Video Products Technical Bulletin 30-2004-129

SUBJECT: WHITE BALANCE ADJUSTMENT FOR MZ CRT

MODEL: **PVM-14L5**
PVM-20L5
PVM-D14L5A
PVM-D20L5A

Figure 1

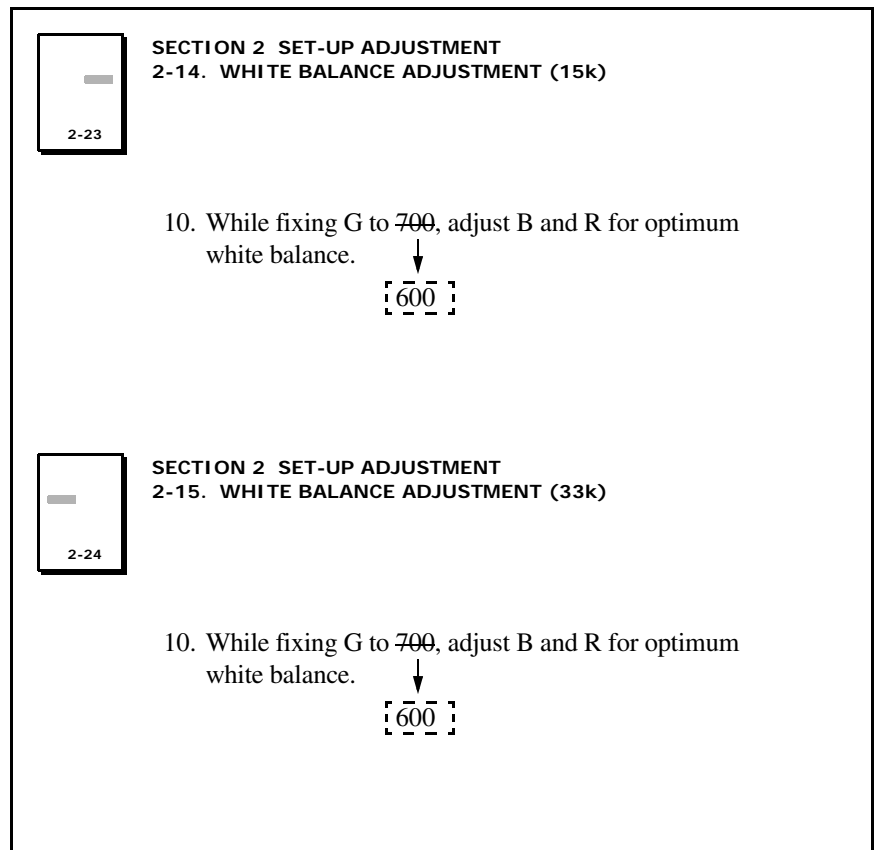
A new white balance adjustment value is required for monitors that have the new MZ-type CRT instead of the MT-type CRT. Use the new value as shown in the following manual correction.

Correct the white balance adjustment value in the *PVM-14L5 Service Manual* (Rev. 1) as shown in Figure 1.

NOTE: Use the new white balance adjustment value whenever you replace the CRT with an MZ-type CRT, even in units with serial numbers other than those listed in this bulletin.
